PRELIMINARY PRINT:
NOT FOR CONSTRUCTION
WISCONSIN HOMES, INC.

Ideas for porch revisions:

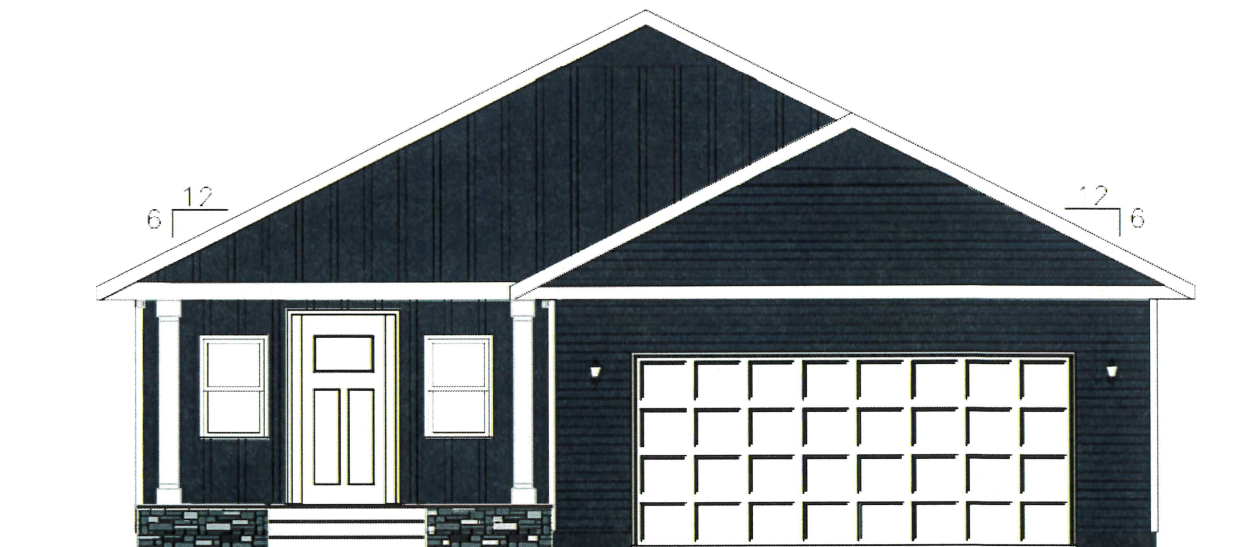
- swap window and /or porch rails for other details: lighting, columns, or wider door/window frame
- Minimize # of columns from 4 to 2 - make the two wider with articulation
- Pull columns in from edge of porch
- Wider steps
- Wider trim
- Rock / stone only an option for base of porch

FYI unclear from CAD what this condition is in the front elevation (applies to all concepts)

- wider door/window frame

- wider door/window frame
- wider steps up to porch
- wider trim details
- add trim detail between bottom of vinyl and top of concrete slab?

- with porch rails, make opening in railing wider
- no regular windows, add lights instead

- no side windows on door, two regular windows
- stone on base on porch
